NEW ELEMENTARY AND MIDDLE SCHOOL

CONTENTS - VOLUME TWO

phase	Bid Package No. 2
date	January 3, 2008
ADD	October 17, 2007
ADD	October 26, 2007
ADD	November 2, 2007
ADD	November 5, 2007

project # 06022

Lighting Plan
Sector "K"
E2.12

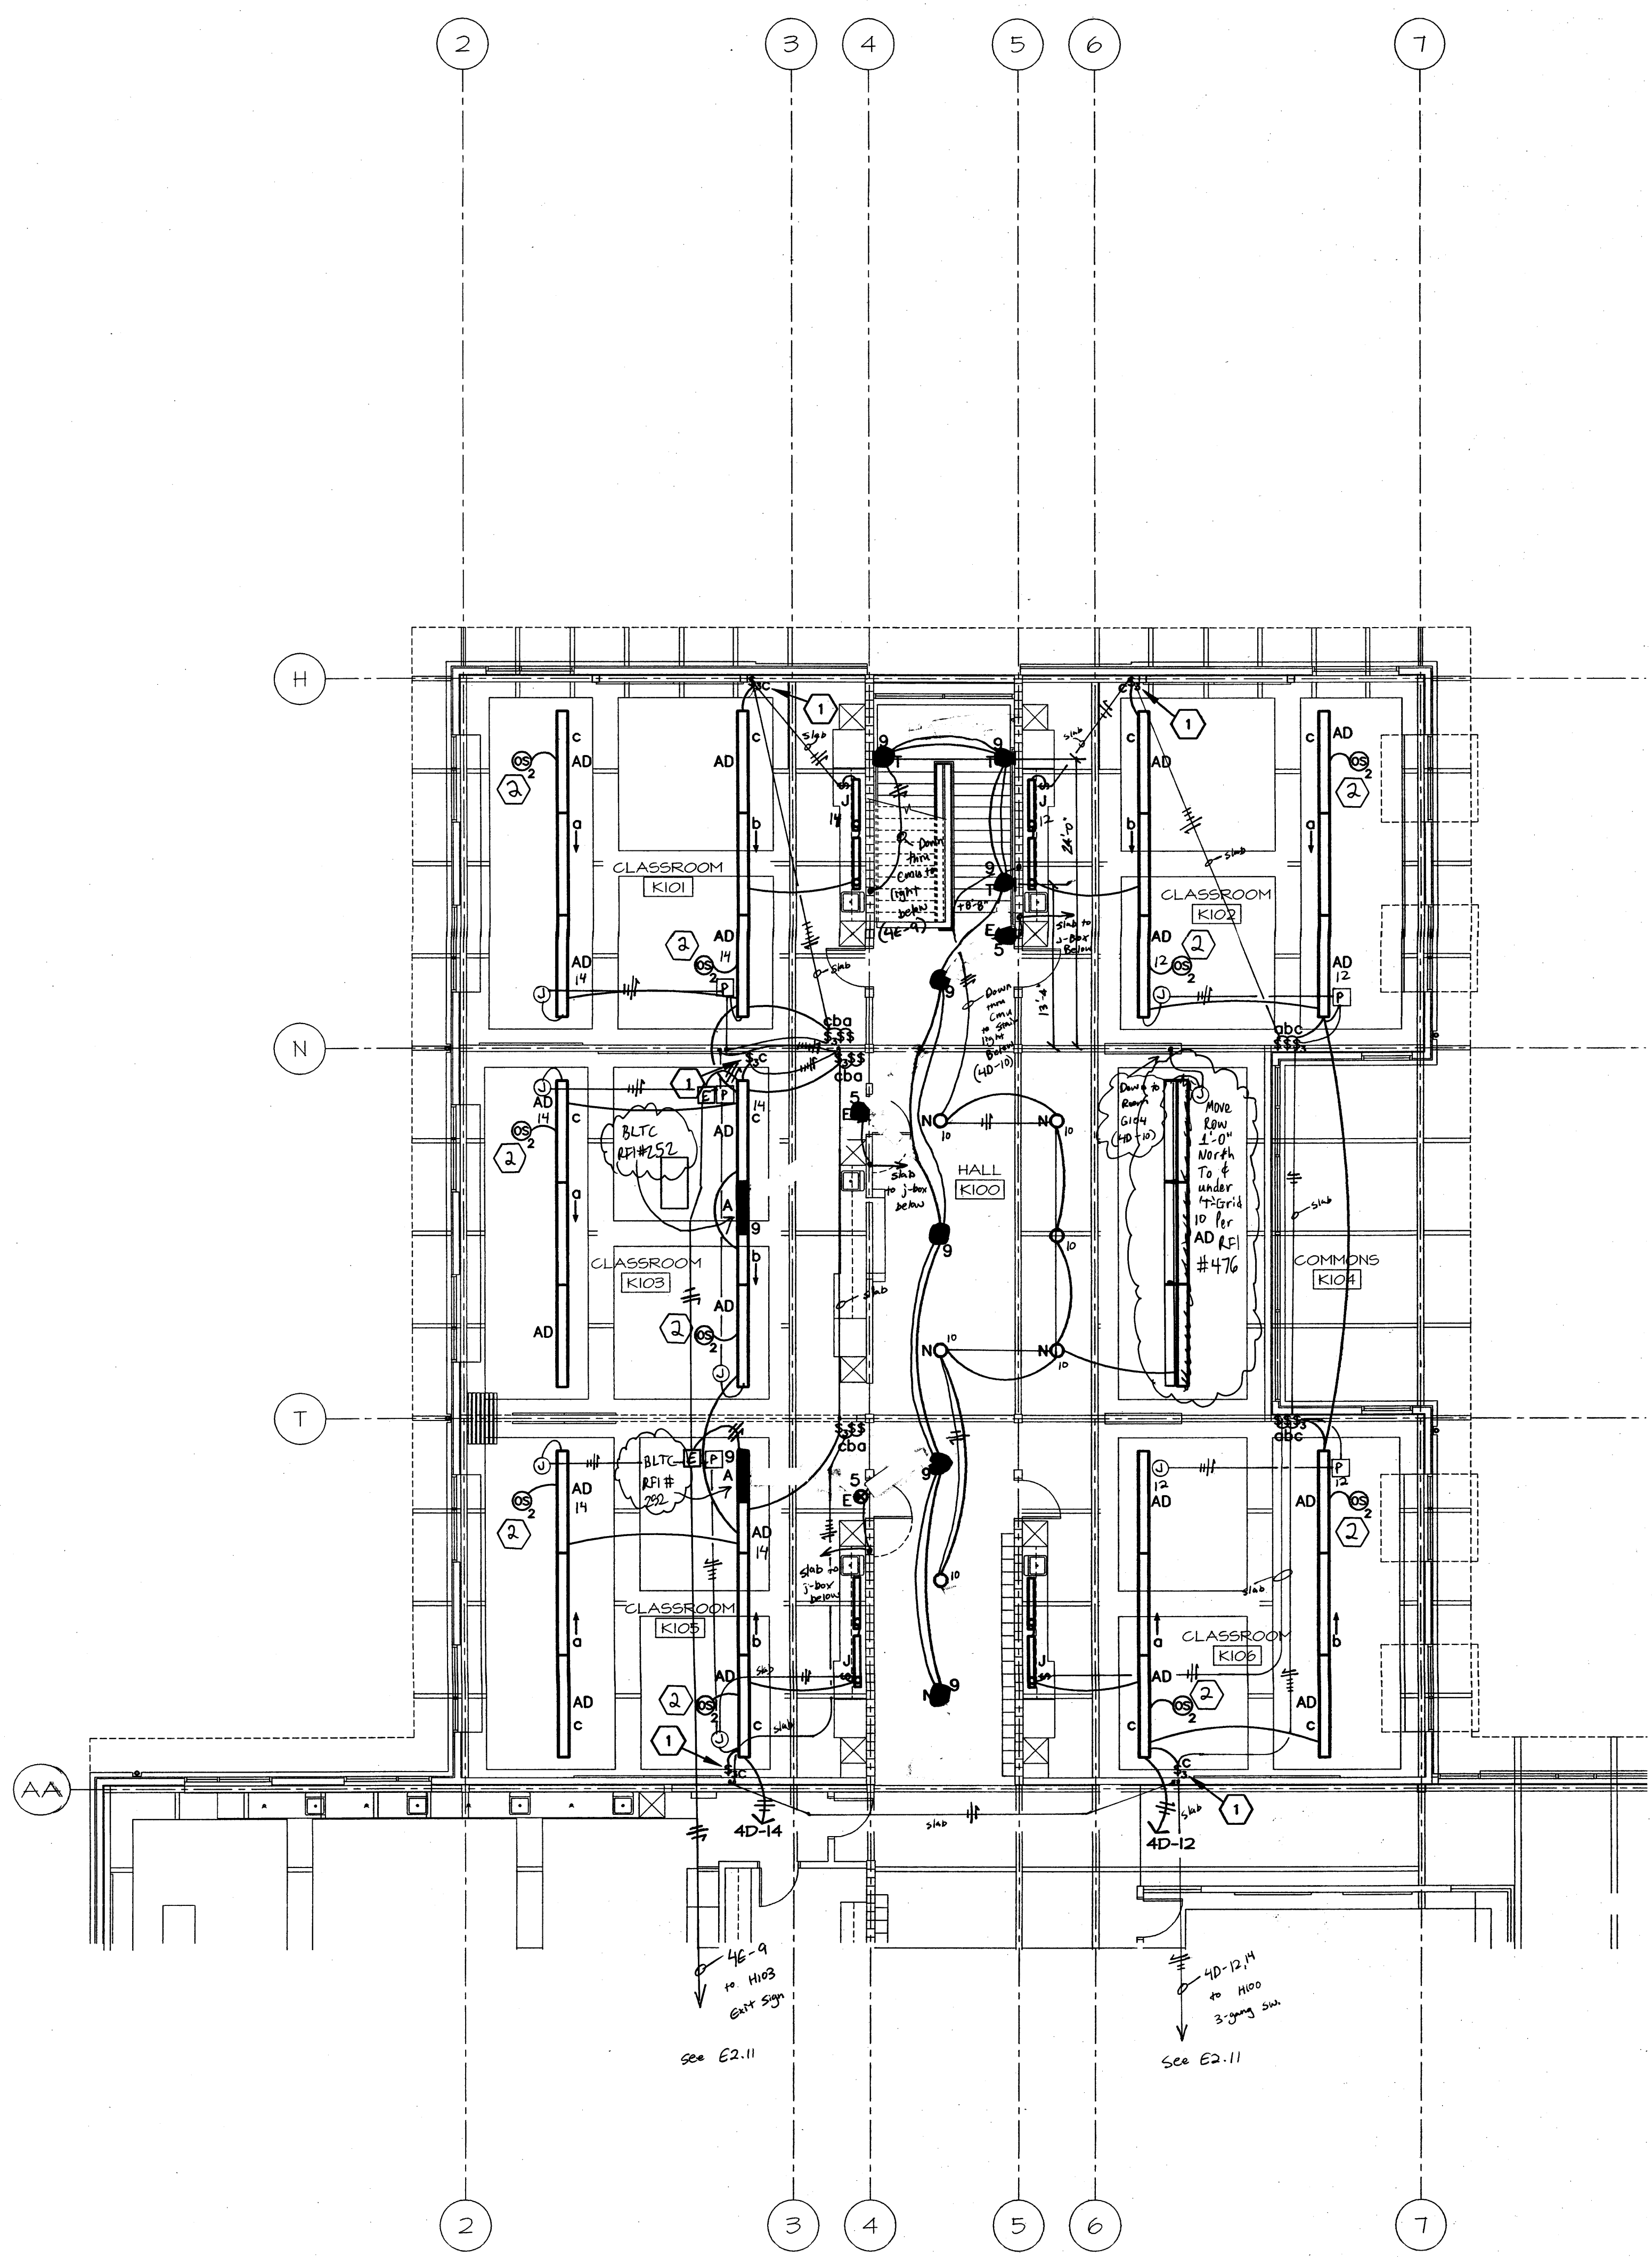
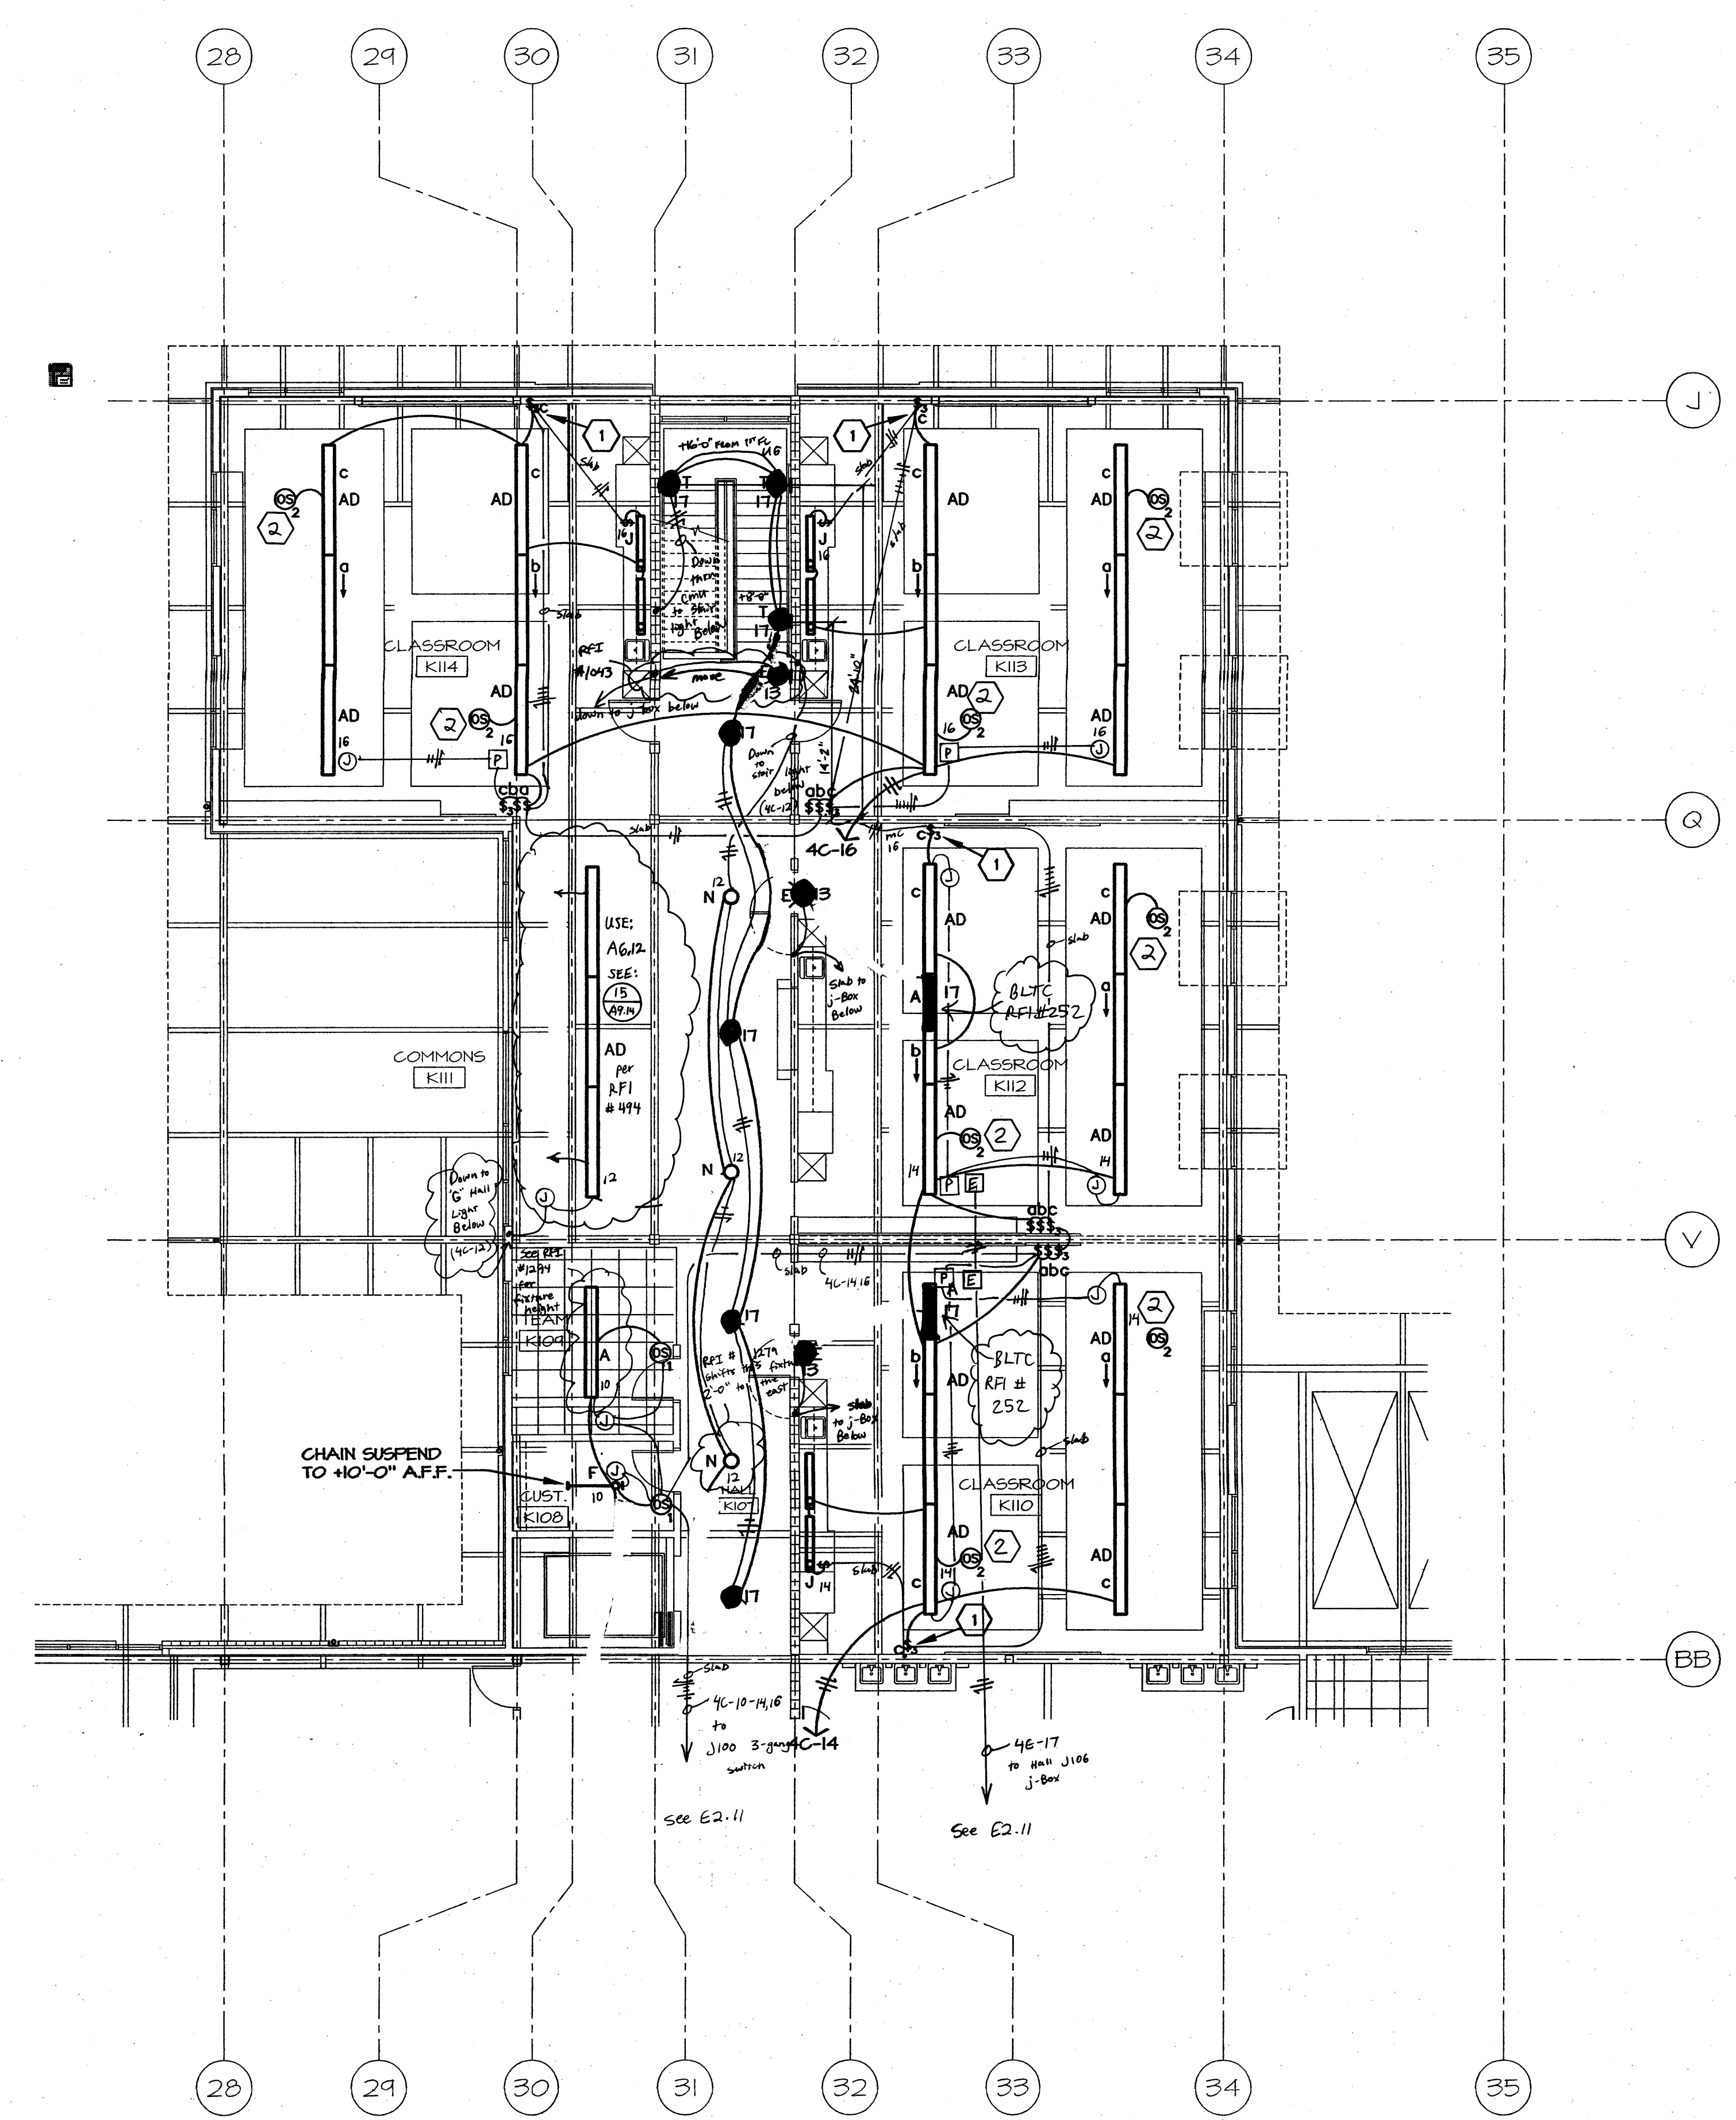
- 1 SWITCH TO BE LOCATED ADJACENT TO 'WHITE BOARD'. COORDINATE EXACT LOCATION WITH ARCHITECT PRIOR TO ROUGH-IN. TYPICAL IN CLASSROOMS.
- 2 TYPE '2' OCCUPANCY SENSORS WORKING IN TANDEM IN EACH NOTED ROOM. Per RFI # 362.

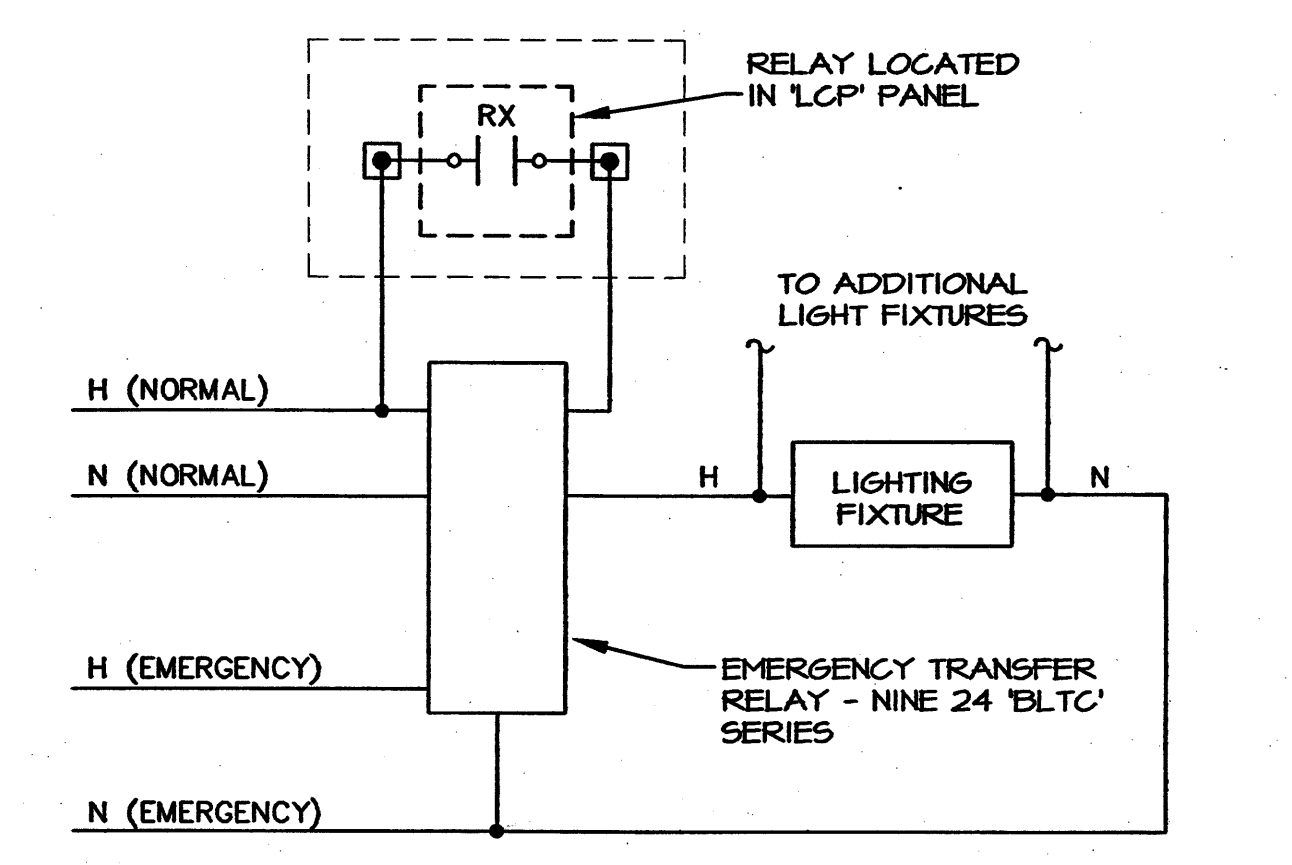
see RFI # 791 on L.V. switches

Note: classroom emergency fixtures off of corridor etc. will need BLTC to turn on w/ classroom Regular lights. Ref: RFI# 252, 670
